ADDENDUM NO. 3

PROJECT NAME: City Wide Bridge Program – East Commerce and East Commerce (North Rio Grande and East Houston)

DATE: February 2, 2015

TCI PROJECT NO.: 40-00294B & 40-00302

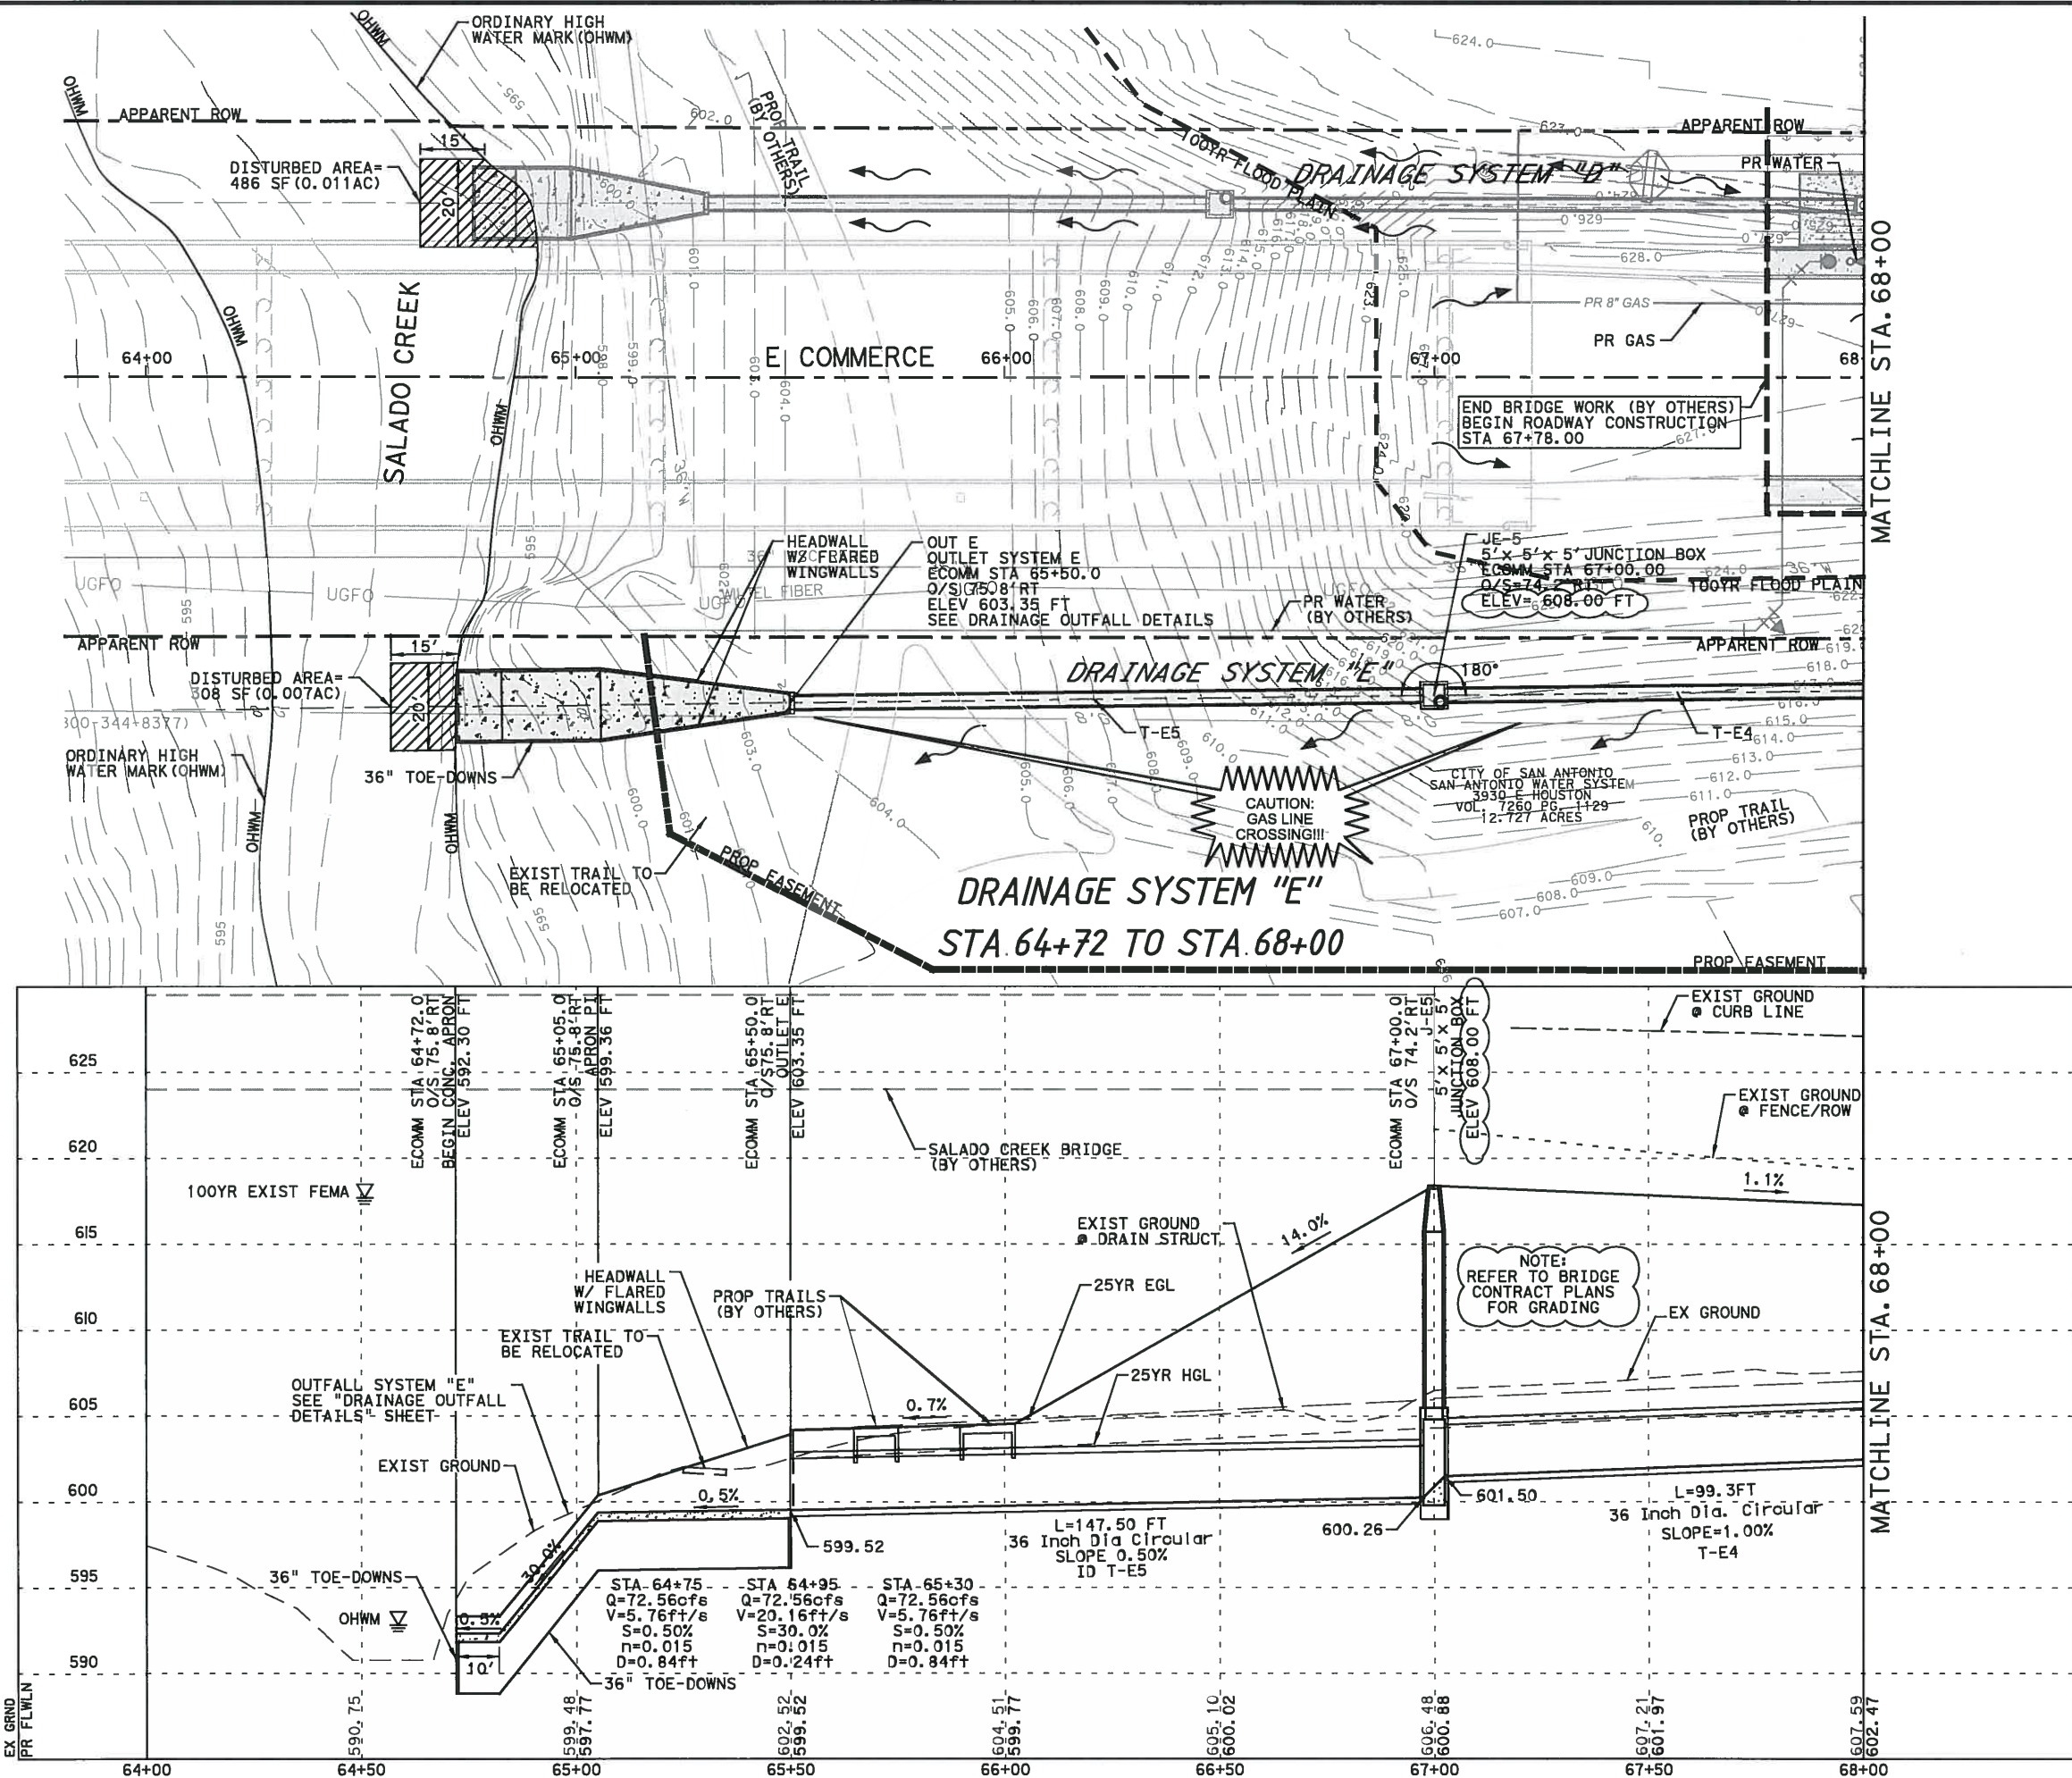
Item 814 – Ductile Iron Pipe has been added
Item 818 – 8" PVC quantity has been changed
 - c. COSA E. Commerce Package B Sidewalk – Base Bid:
Item 107.1 – Embankment Type revised to Type B

- 5) Plans - Replace the following Plan Sheets:**
 - a. Delete Sheet 3 in the CoSA-TCI Project No. 40-00302 Plans and replace with the attached Sheet 3.

1	2-3-15	ADDENDUM 3: REVISED EMBANKMENT DESCRIPTION TO TY B	BMB
REV	DATE	DESCRIPTION	BY
<div><div>BAIN MEDINA BAIN, INC. ENGINEERS & SURVEYORS TYPE F-1712 TRPLS 10020900 7073 San Pedro, San Antonio, Texas, 78216 Phone: 210-494-7223 Fax: 210-490-5120 WWW.BMBI.COM</div><div>CITY OF SAN ANTONIO  DEPARTMENT OF TRANSPORTATION & CAPITAL IMPROVEMENTS E. COMMERCE FROM N. RIO GRANDE TO E. HOUSTON PROJECT QUANTITY SUMMARY</div></div>			
FINAL DESIGN	PROJECT NO: 40-00302	DATE: 2/3/2015	
DRWN BY: CDA/MC	DSGN BY: CC/CDA	CHKD BY: LOW/CB	SHEET: 3

- i. PI is not specified but material must meet the density compaction per COSA specification 107. In addition, the embankment type for both projects will be (Final)(Density Controlled)(TY B).*

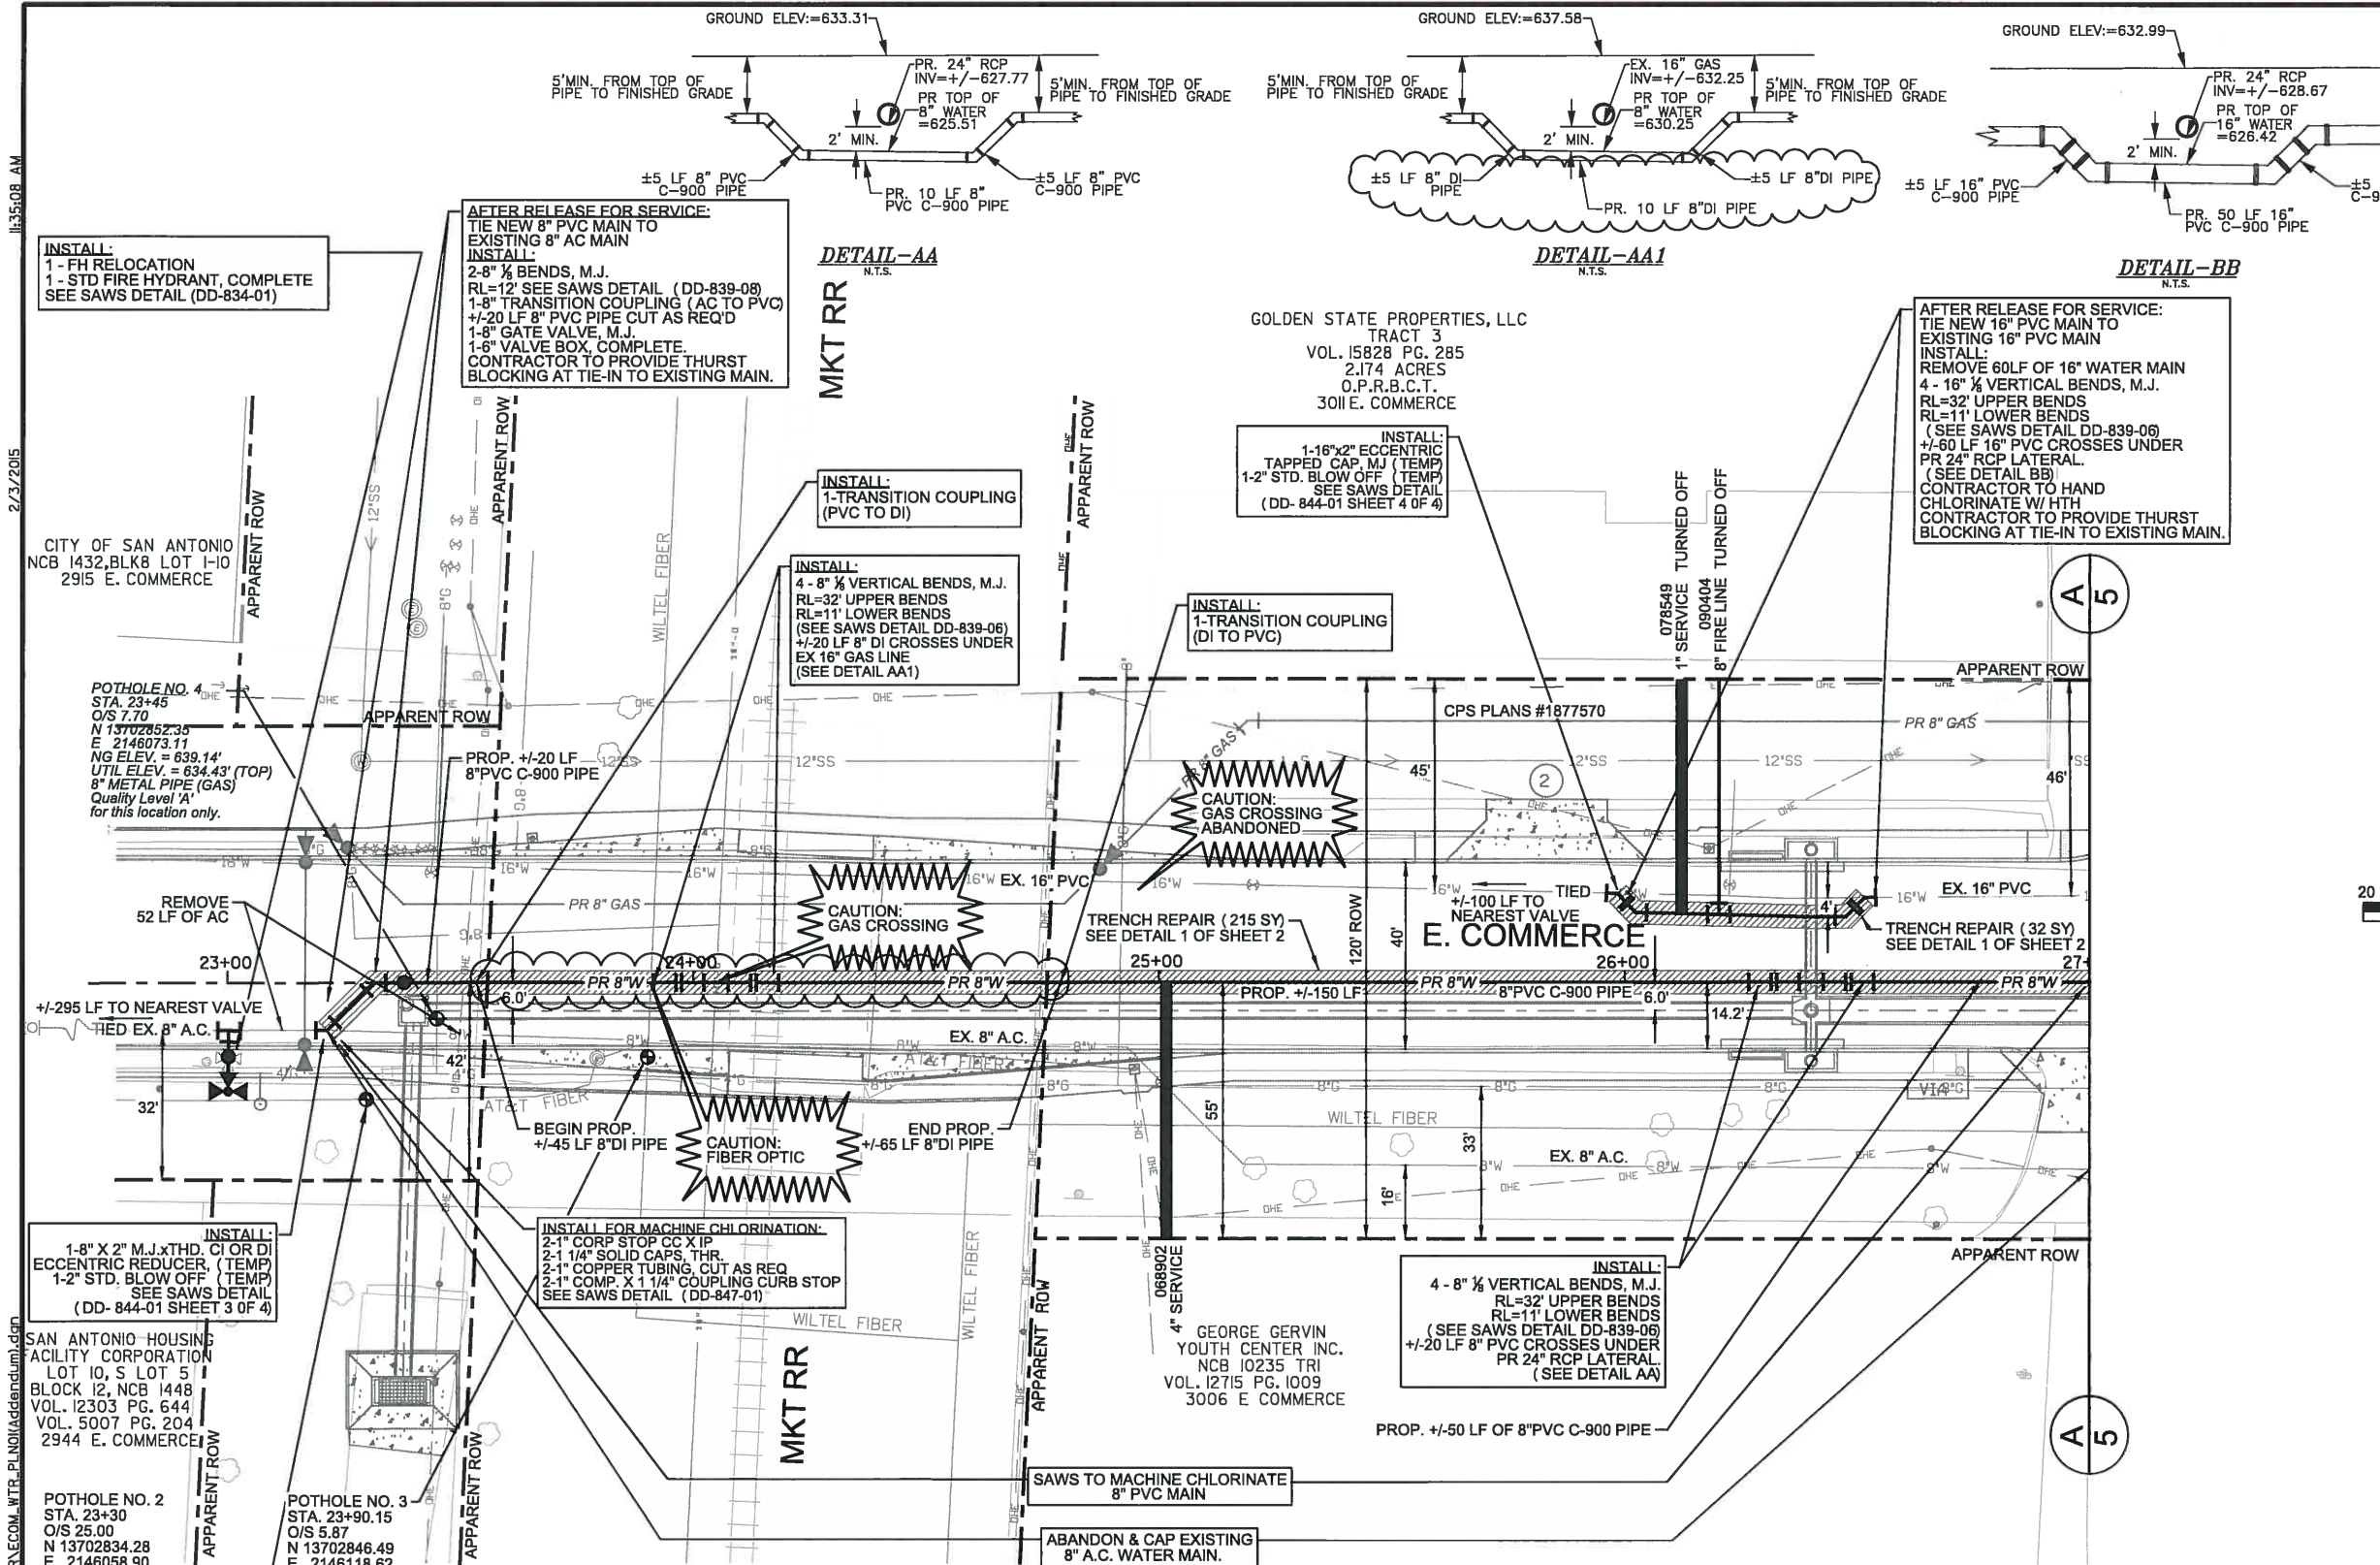
- b. Delete Sheet 114 in the CoSA-TCI Project No. 40-00302 Plans and replace with the attached Sheet 114.
- c. Delete Sheet 2 in the SAWS Job No. 12-5089 Water Plans and replace with the attached Sheet 2. The quantities have been updated and are shown in the summary table.
- d. Delete Sheet 4 in the SAWS Job No. 12-5089 Water Plans and replace with the attached Sheet 4. The quantities have been updated and are shown in the quantity table.
- e. Delete Sheet 2 in the SAWS Job No. 12-5589 Sanitary Sewer Plans and replace with the attached Sheet 2. The quantities have been updated and are shown on the summary table
- f. Delete Sheet 13 in the SAWS Job No. 12-5589 Sanitary sewer plans and replace with attached Sheet 13. The quantities have been updated and are shown in the quantity table.

1	2-3-15	ADDENDUM 3: ADDED 8"DI & REVISED 8"PVC QUANTITY	BMB
REV	DATE	DESCRIPTION	BY
		BAIN MEDINA BAIN, INC. ENGINEERS & SURVEYORS TYPE F-001712 7073 San Pedro, San Antonio, Texas, 78216 Phone: 210-494-7223 Fax: 210-490-5120 WWW.BMBI.COM	
		E COMMERCE FROM RIO GRANDE TO E HOUSTON GENERAL NOTES & QUANTITIES	
DEVELOPER:		BUDGET PROJ.	
CONT.			
SUBMITTED			
APPROVED			
MAP No.		SHEET	
SECT. No.		2	
DR. MC		OF 16	
CK. CC/CB		FINAL DESIGN	
JOB No.		12-5089

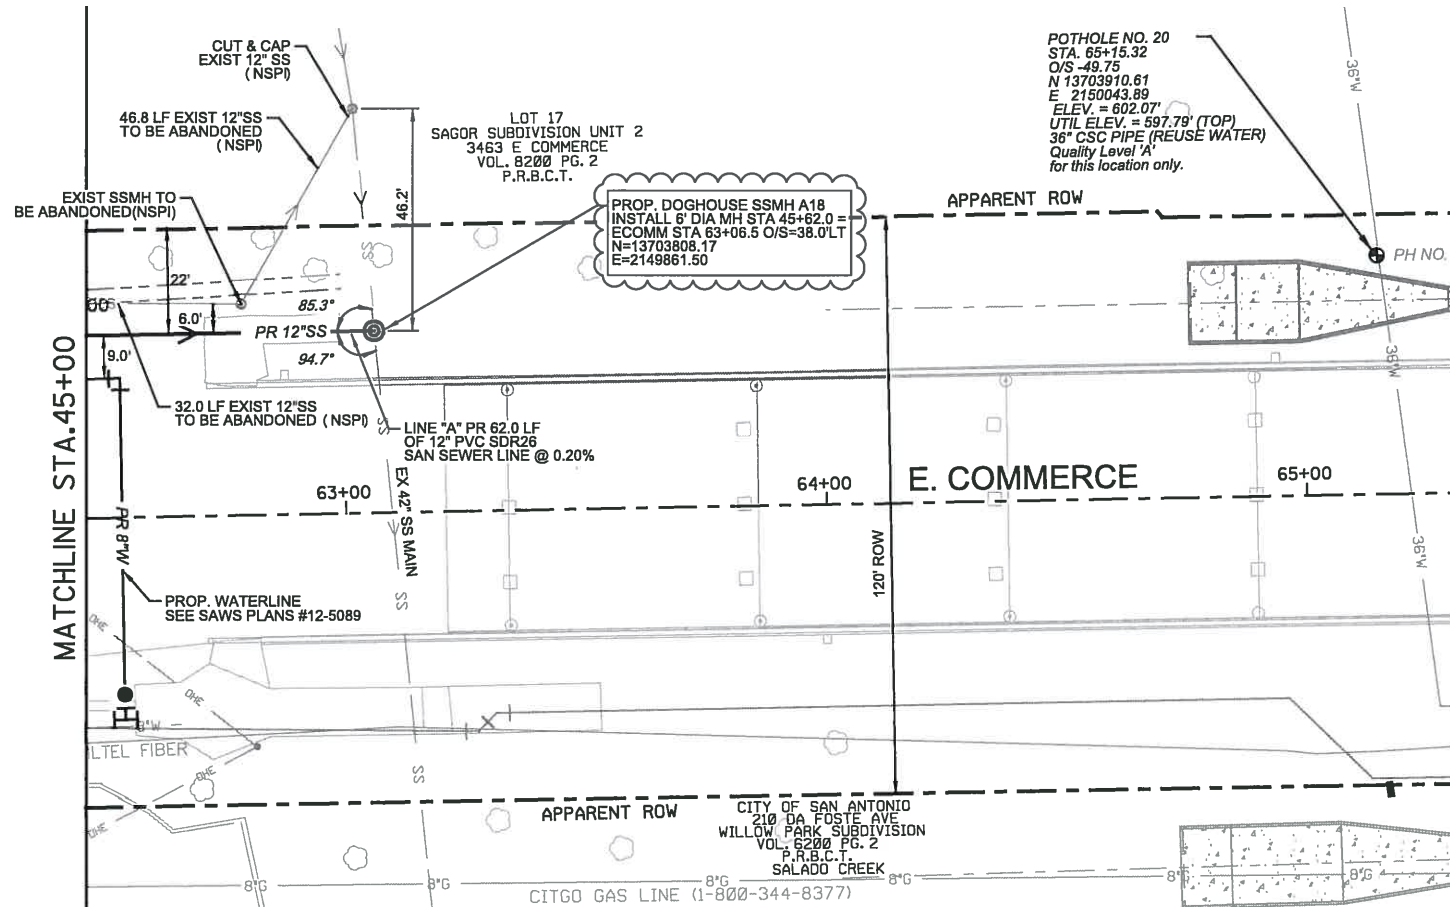
- 8. The 42" Sanitary Sewer (Existing) is calling for a 4' Doghouse manhole. Will this be sufficient? We are thinking a 6' one at minimum will be required.

1	2-3-15	ADDENDUM 3: REVISED DESCRIPTION TO DOG HOUSE MANHOLE (6')			BMB
REV	DATE	DESCRIPTION			BY
		BAIN MEDINA BAIN, INC. ENGINEERS & SURVEYORS TYPE F-001712 7073 San Pedro, San Antonio, Texas, 78216 Phone: 210-494-7223 Fax: 210-490-5120 WWW.BMBI.COM			
		E COMMERCE FROM RIO GRANDE TO E HOUSTON GENERAL NOTES & QUANTITIES			
DEVELOPER:					
CONT.		BUDGET PROJ.			
SUBMITTED _____					
APPROVED _____					
MAP No.					SHEET
SECT. No.		FINAL DESIGN			2
DR. MC	CK. CC/CB	JOB No.		12-5589	OF 16

- i. The 4 ft Doghouse Manhole has been revised to a 6 ft Doghouse Manhole, see revised plan sheet included.*
